Preventive grinding of exhaust valve seats

SL2022-729/AGC
September 2022

Owners and operators of MAN B&W two-stroke marine combustion engines.
Type: All 30-98 bore engines with exhaust valve seats of the wide seat type.

Preventive grinding of the exhaust valve spindle seat and bottom piece seat is introduced as a requirement. To allow for the planning of the overhaul work, this takes effect from the date of this service letter plus six months.

Spindle seat seen from top.

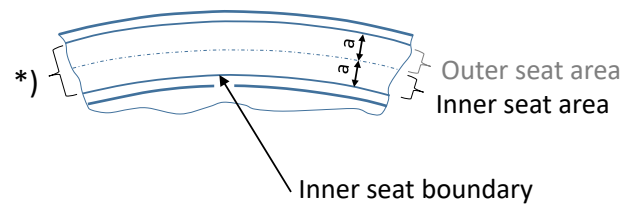
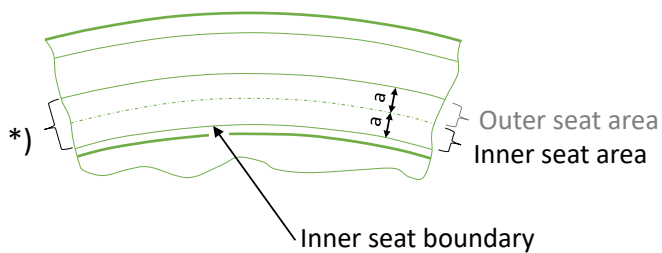
In the event of dent marks exceeding Ø2 mm after 0.5 mm spindle seat grinding, evaluate according to the sketch below.

***) Seat contact area: spindle seat >< bottom piece seat.**

Spindle outer seat area

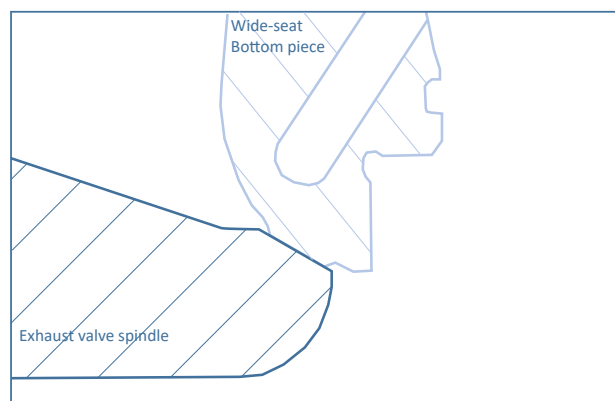
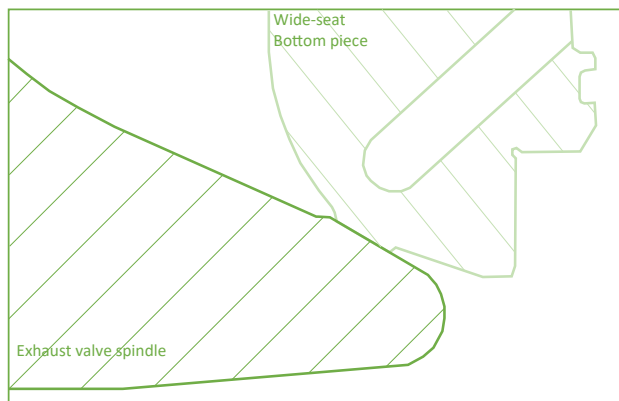
Dent marks exceeding Ø2 mm can be allowed, but the size must not exceed 8 mm size in any direction, and the dent mark must not affect the inner seat area.

Dentmark on inner seat area

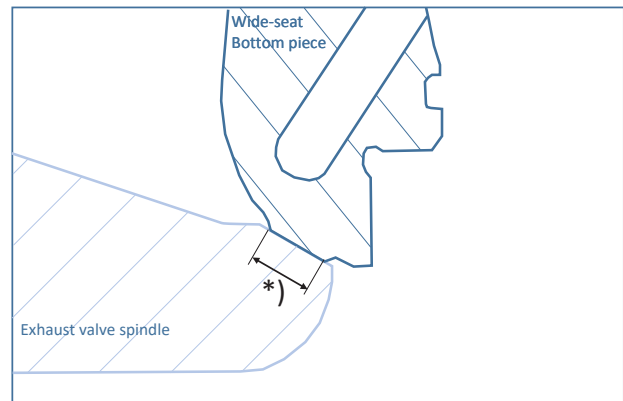
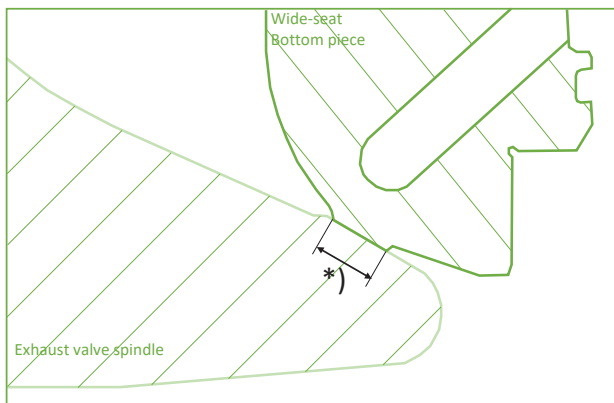
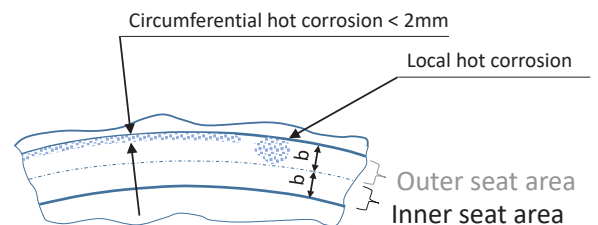
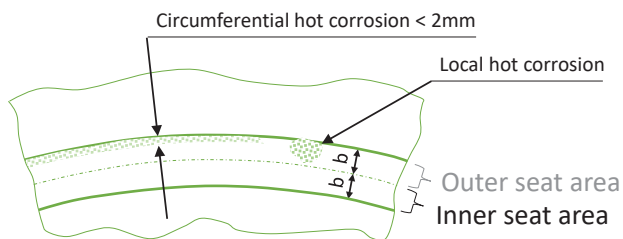
- 1) Size > 2mm in any direction.
- 2) Distance from inner seat boundary less than 4mm.
- 3) Connected small dentmarks considered as one > 4mm in size.

Service acceptance criteria for bottom piece seat.**Bottom piece seat seen from below.****Bottom piece outer seat area**

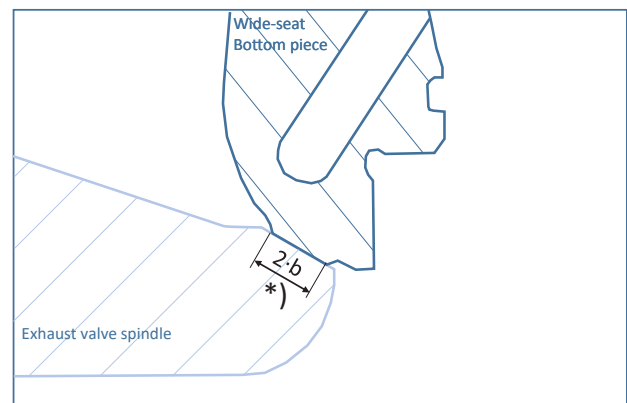
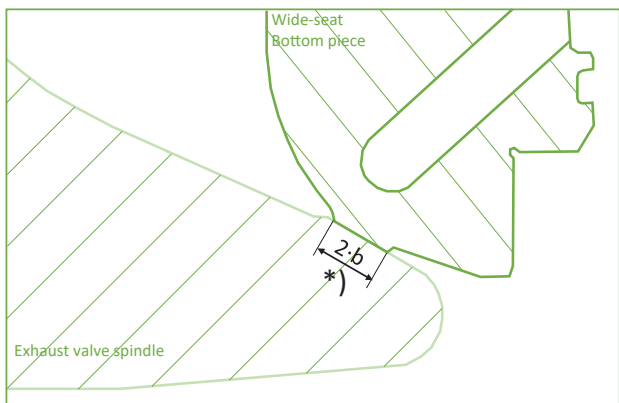
- Hot corrosion at the outer boundary of the bottom piece seat area must not exceed 2 mm width.
- Local hot corrosion on the bottom piece outer seat area, and only affecting the outer seat area, can be accepted if the maximum size in any direction does not exceed half the seat length. Half seat length indicated with “b” in the sketch above. Maximum one local hot corrosion spot of half seat length size can be accepted.
- Dent marks exceeding Ø2 mm can be allowed on the outer seat area provided that the inner seat area is unaffected.
